SECTION 12A PLANNING APPLICATION NO. Y/YL-TYST/12

Further Information Submission

Section 12A Planning Application No. Y/YL-TYST/12

Response to Departmental Comments Table

SK-05_rev.7

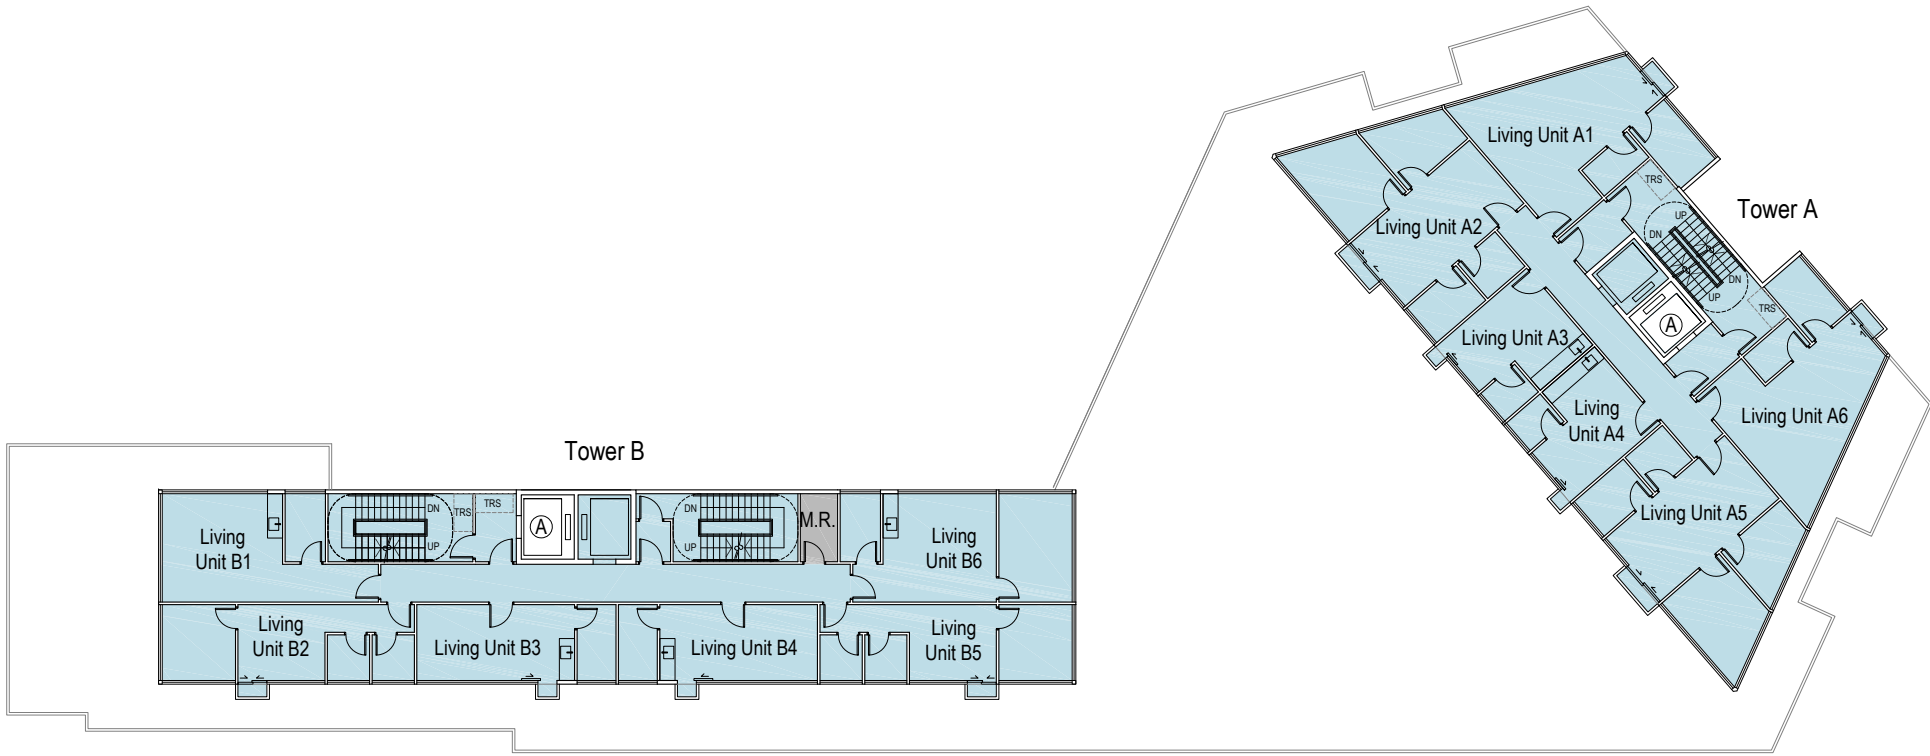
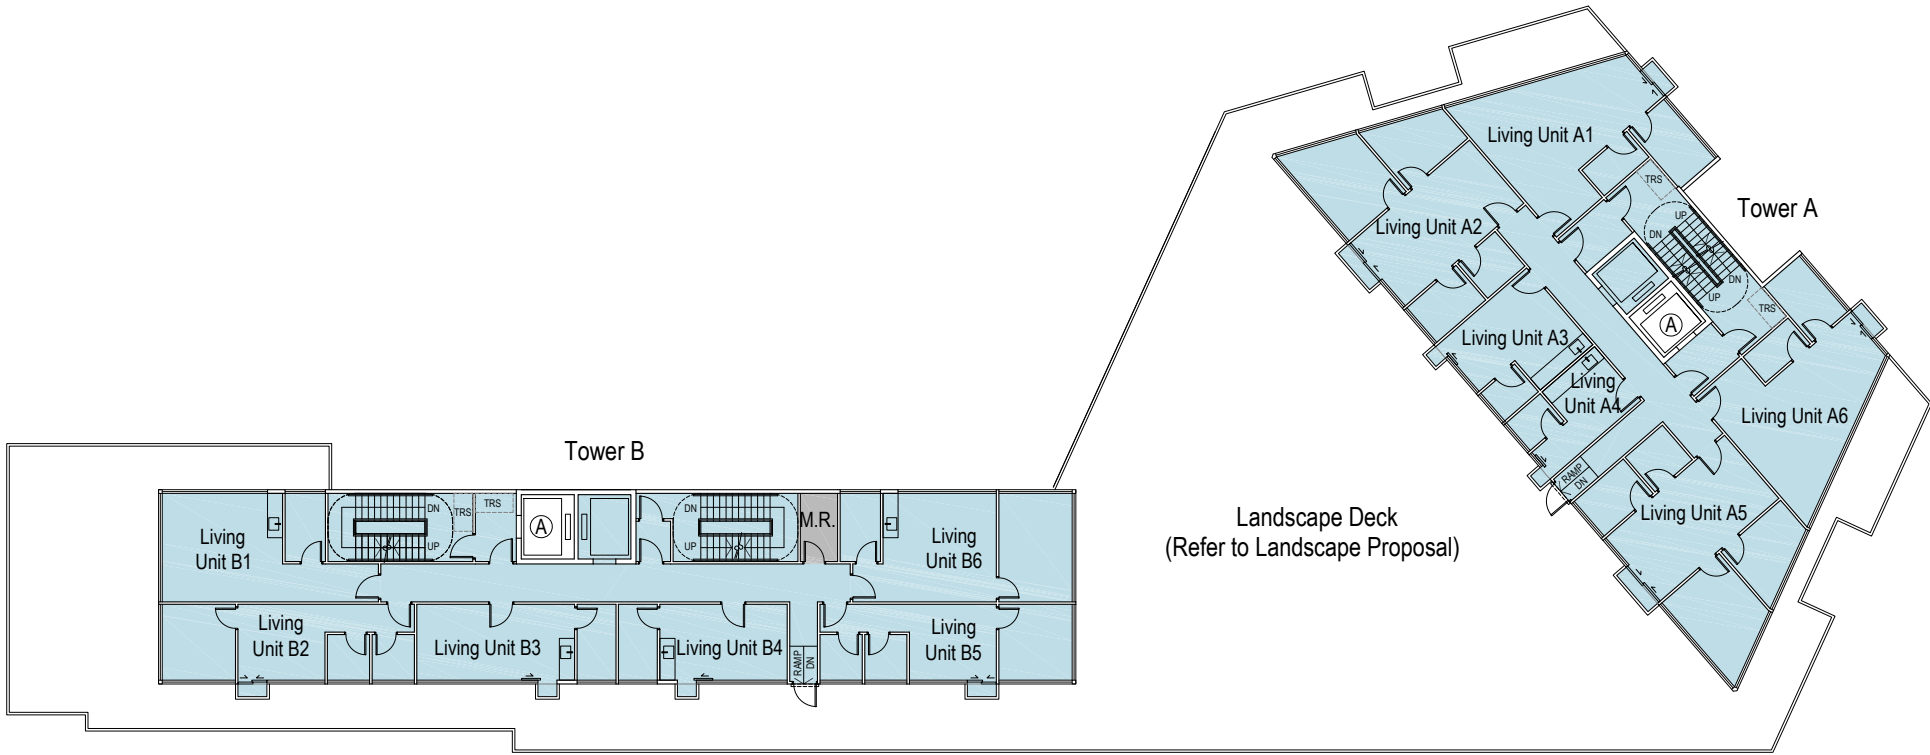
No.	Comments Received	Our Responses
	Please review if it is an internal staircase serving RCHE only, as it is accessible by domestic residents on 6/F according to proposed layout plan. While the development is shaded in different colours for demarcation purpose, the applicant is advised to demarcate the RCHE area intended for calculation of RCHE GFA in one color for our easy reference. 	Colour legend of the Indicative Architectural Drawings (Appendix 1) has been updated for easy reference.
	To safeguard the privacy of staff, provision of Staff Changing Room/Staff Toilet/Bathroom should be provided separately for male and female staff.	The 6/F floor plan of the Indicative Architectural Drawings (Appendix 1) has been updated regarding the separation of male and female staff changing rooms/ staff toilets/ bathrooms.
	The names of Sick/Isolation/ Quiet Room cum End-of-Life Care Room, Dining/Multi-Purpose Area, Multi-Purpose Room and Multi-Purpose Room/ Rehabilitation Area on the layout plan do not tally with the provisions on the SoA list (Encl 6). Please review and revise the names of the provision accordingly.	Proposed Schedules of Accommodation for the RCHE (Appendix 2) has been revised accordingly.

Figure 2-1 **500m Assessment Area** and Location of Representative ASRs

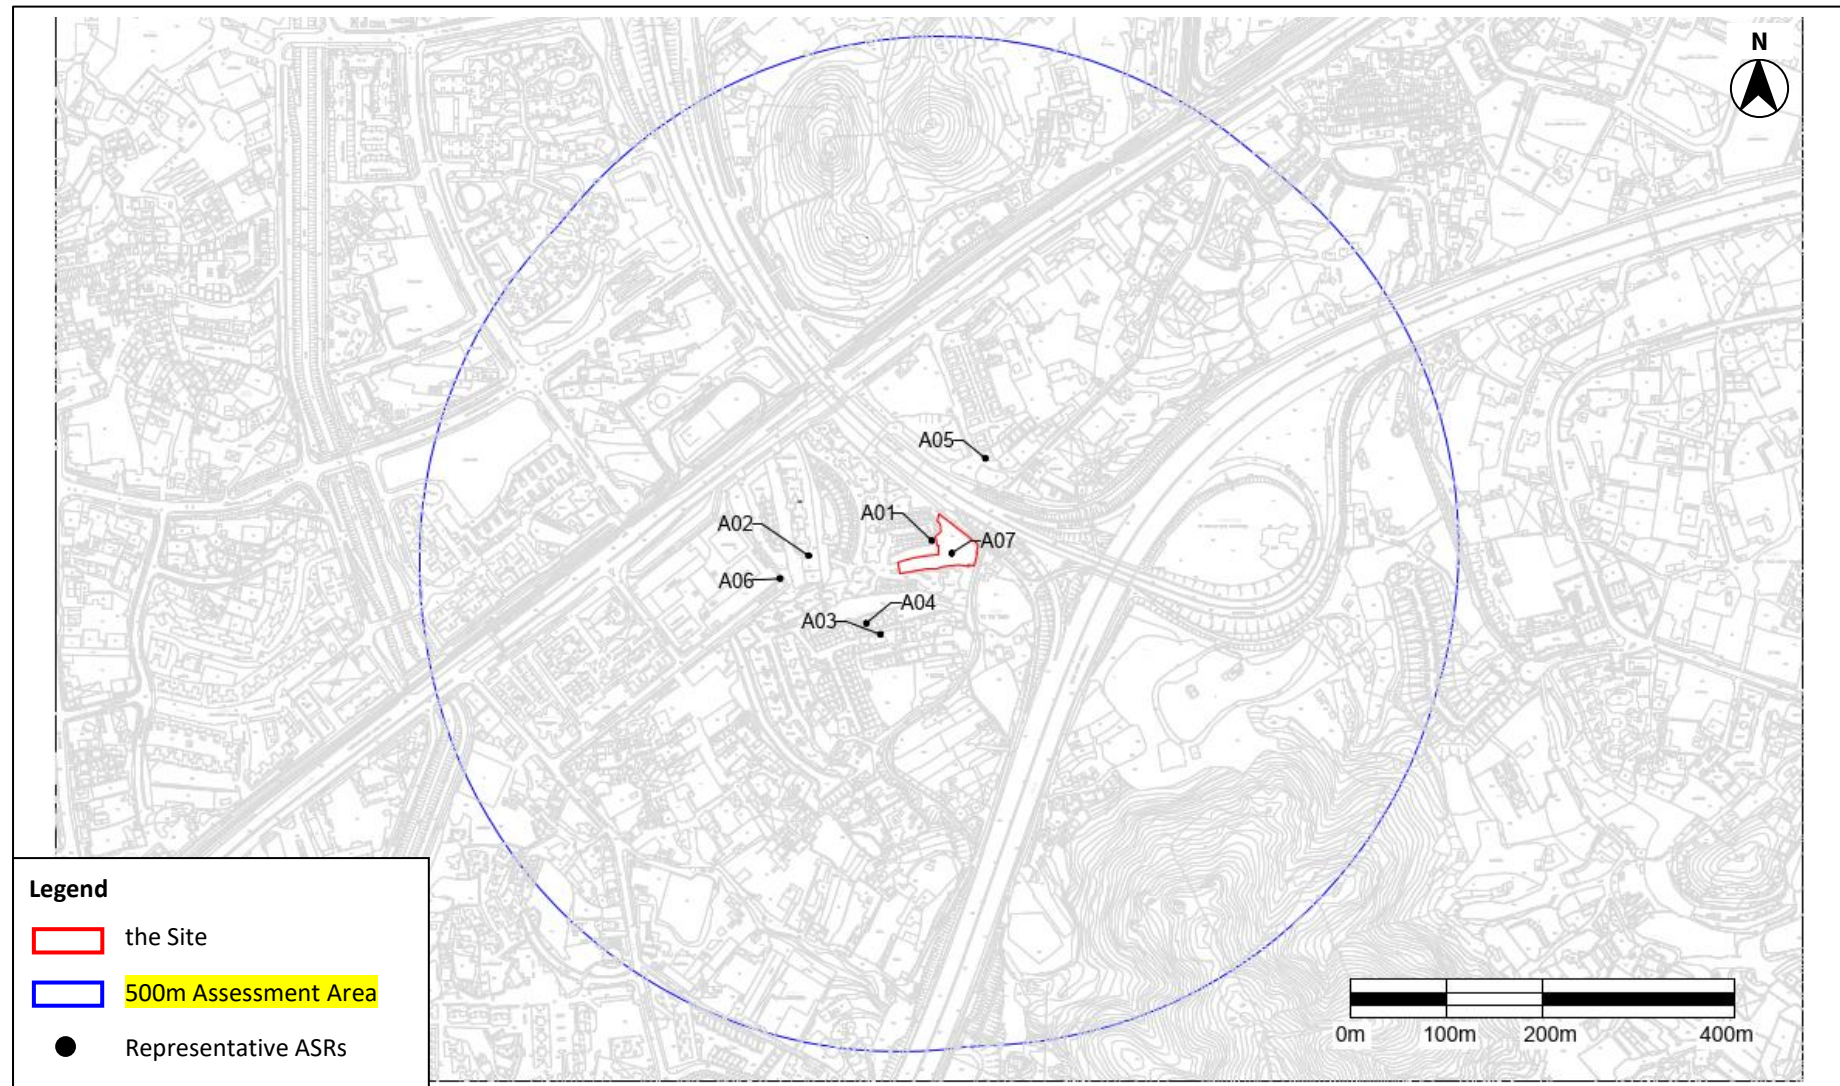
12.	Figures 2-1 and 2-3	/

No.	Comments Received	Our Responses
	a) Suggest to revise "500m Study Area" to "500 Assessment Area" in the title and legend.	Figures 2-1 and 2-3 of EA have been revised accordingly.
Noise		/

FIGURE S3

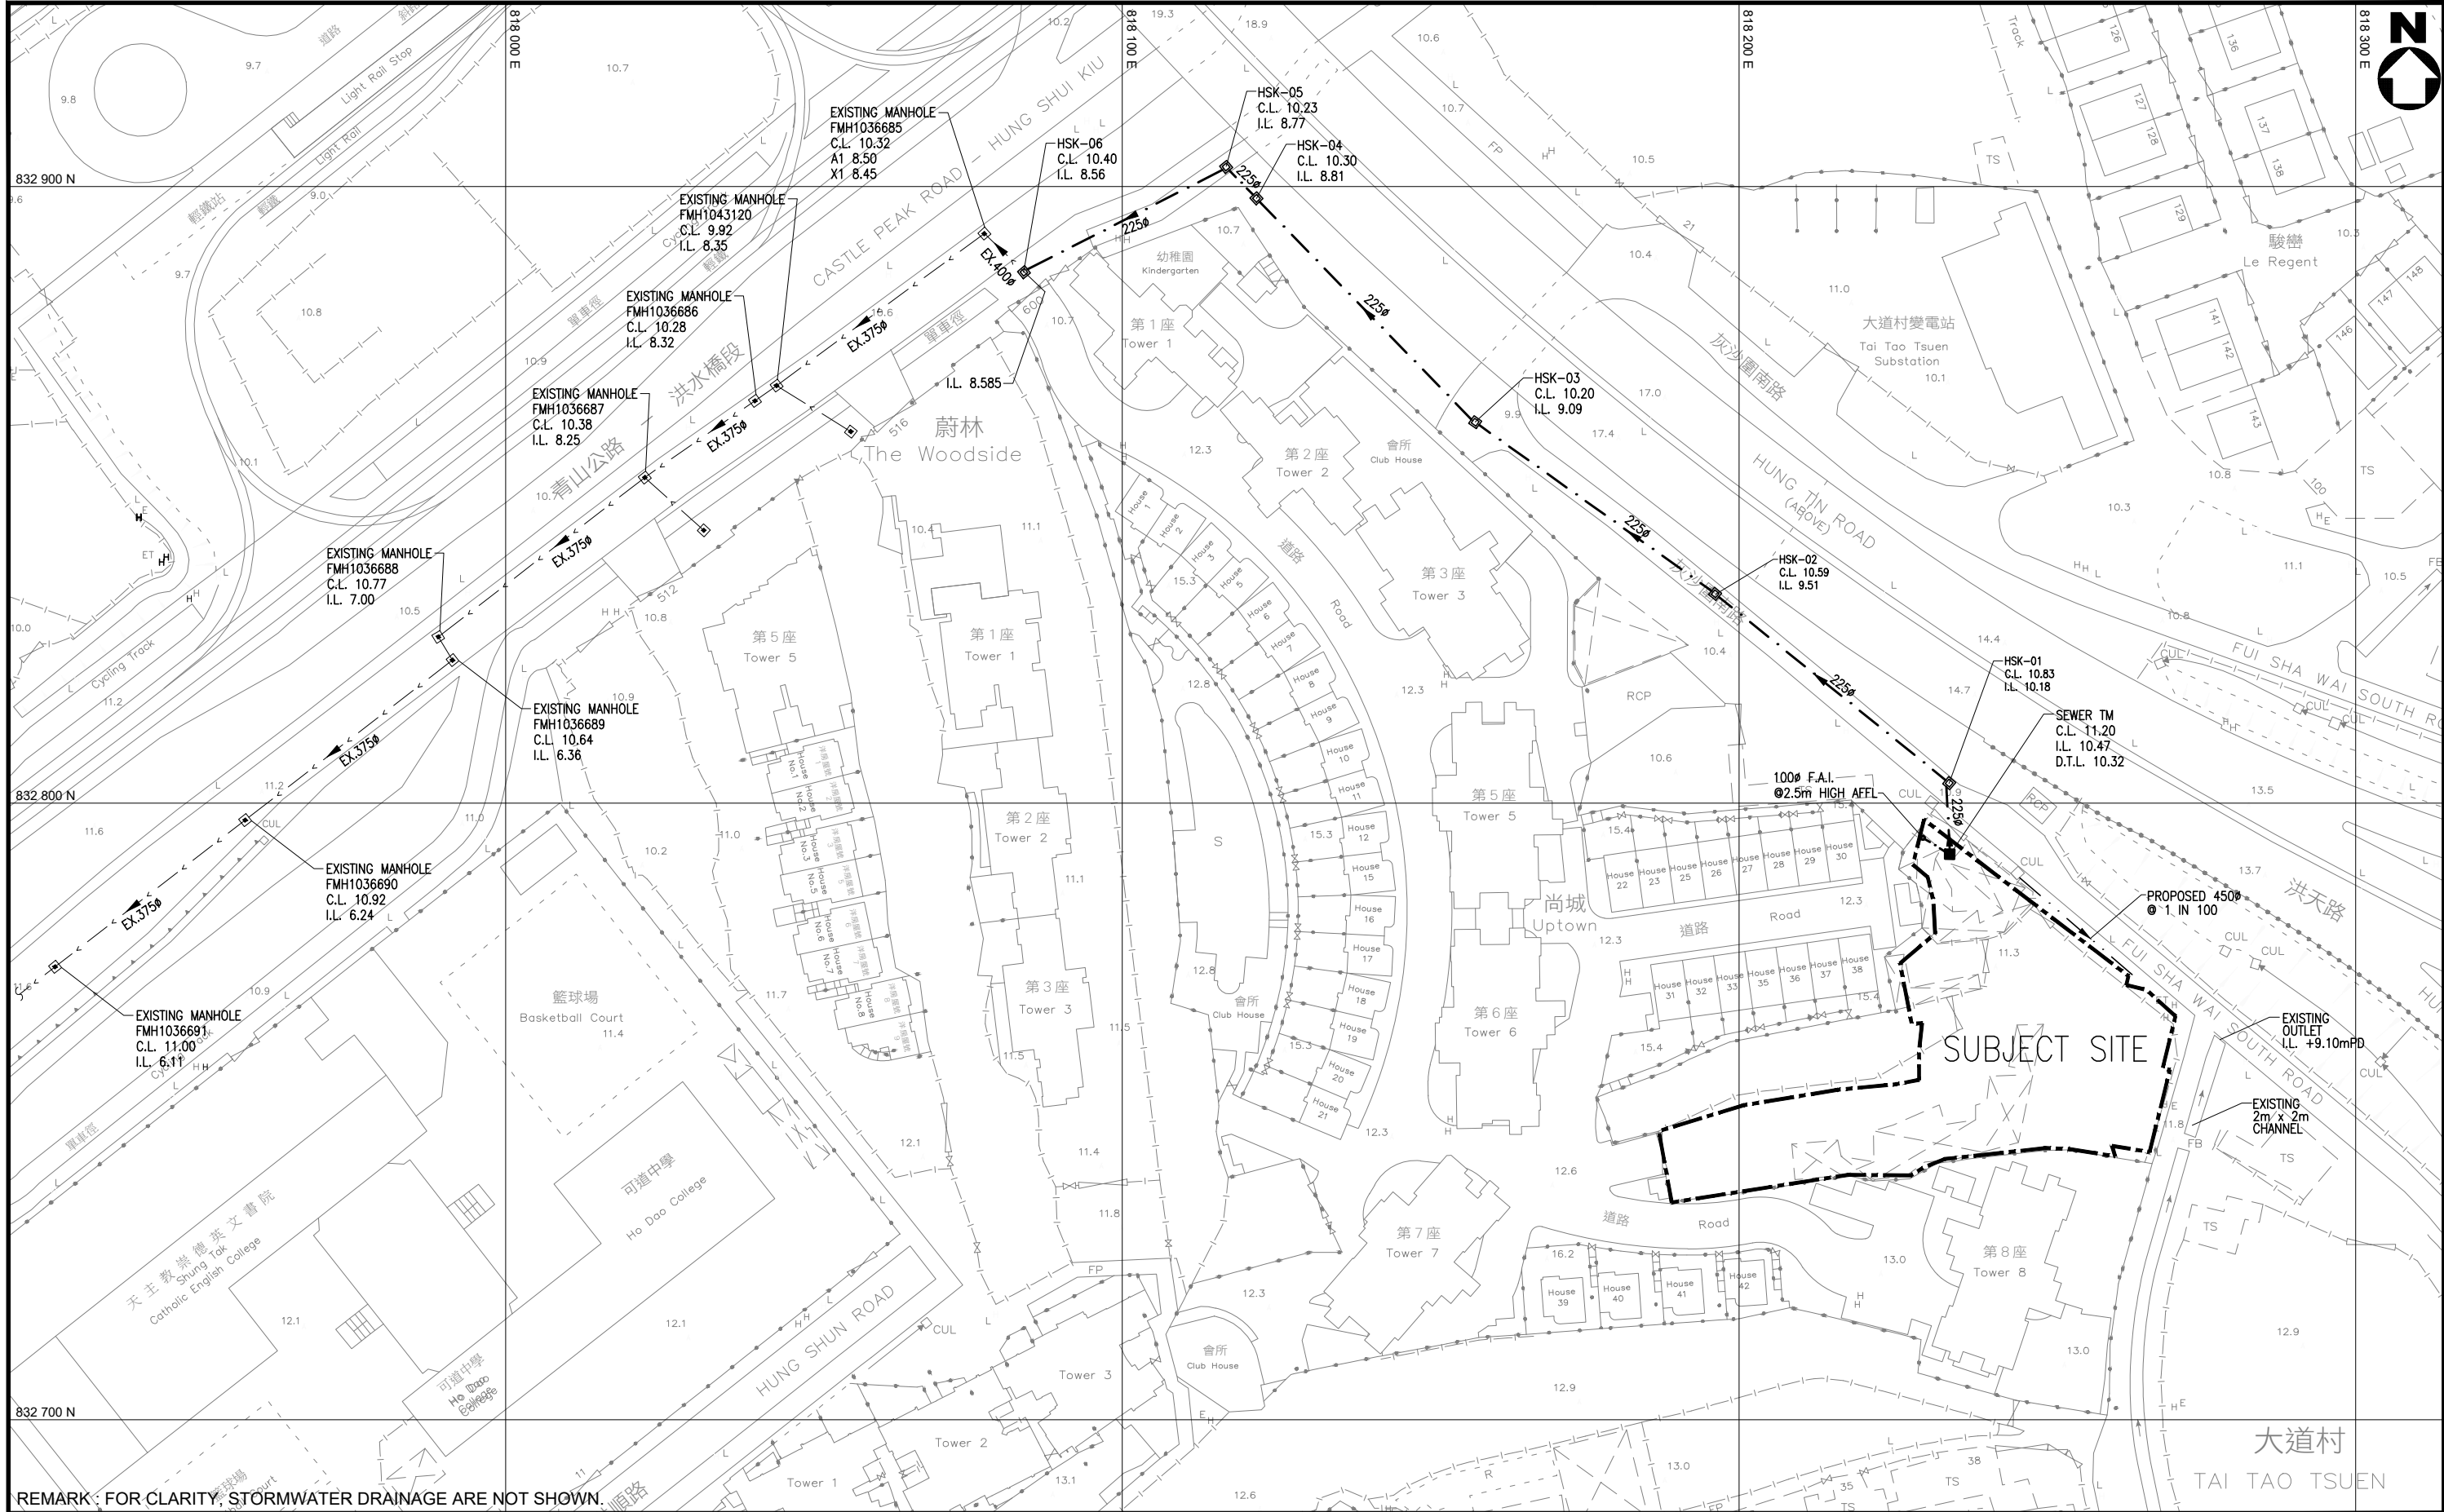
i.	Page 2 of the report repeated, please review.	It might be a clerical error and should have been avoided in the resubmission.
ii.	Figure D4 is not the same version as the submitted DIA, please review.	Please note the two aforementioned Figure D4 of Drainage Submission and Sewerage Impact Assessment (SIA) (Appendix 5) are different, that have been included different submissions under which the site boundaries are not the same. Figure D4 enclosed in the Appendix 2 of SIA is a record and is referred to the documents submitted to the Buildings Department in support of the Drainage Plan for approval in 2022 and for information only in the subject SIA. Yes, the mentioned Figure D4 is not the same version as the submitted Drainage Submission.
iii.	According to our record, the invert level of the outlet (i.e. X1) at FMH1036685 is +8.45mPD. Please review the relevant drawings and calculations.	Figure S3 of SIA has been revised accordingly.

FIGURE D5

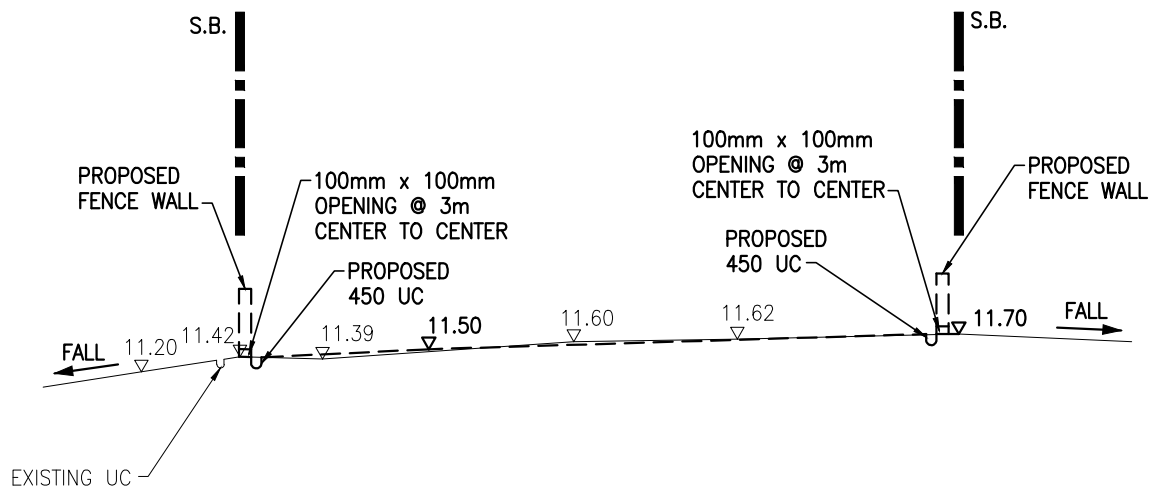
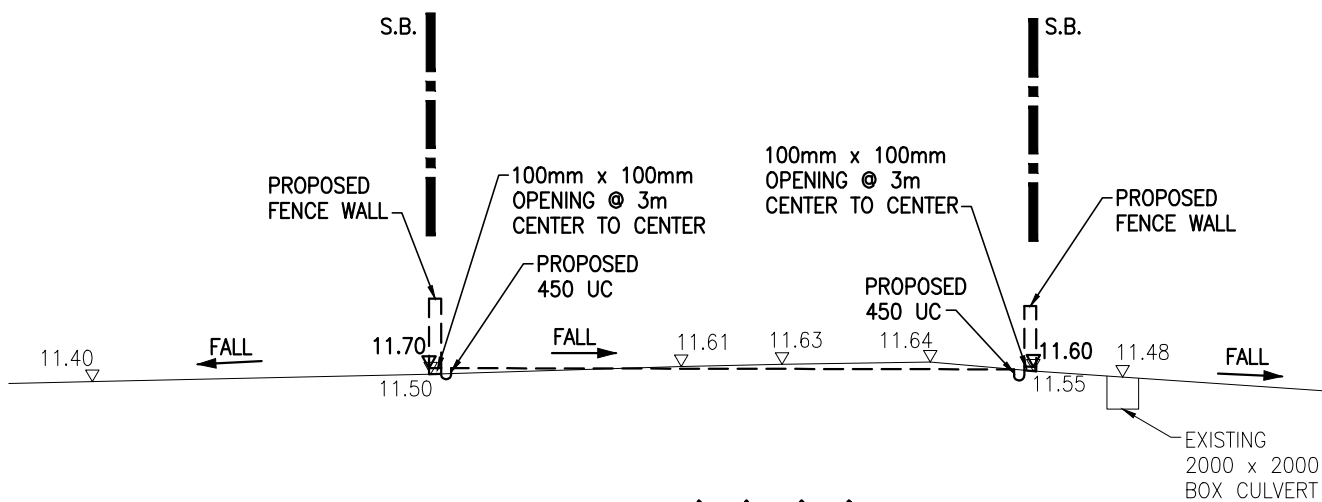
i. Cross sections showing the existing and proposed ground levels of the captioned site with respect to the adjacent areas should be given.	Figure D5 of Drainage Submission (Appendix 6) has been supplemented regarding the site sections of the existing and proposed ground levels of the Subject site.
	ii. Appendix – Please review the invert level difference for CP1.1-CP1.2, CP1.4-CP1.5, CP2.2-CP2.3, CP2.3-CP2.4, CP2.8-CP2.9, CP2.9-TM and Point Z-Point Y under Column (8) which seems not consistent with the difference between Column (6) and Column (7).	Please note the invert level difference for CP1.1-CP1.2, CP1.4-CP1.5, CP2.2-CP2.3, CP2.3-CP2.4, CP2.8-CP2.9 and CP2.9-TM under Column (8) apparently not consistent with the difference between Column (6) and Column (7) is due to rounding. To clarify, figures in Column (6), Column (7) and Column (8) are now shown in 3 decimal places in the updated Appendix of Drainage Submission .
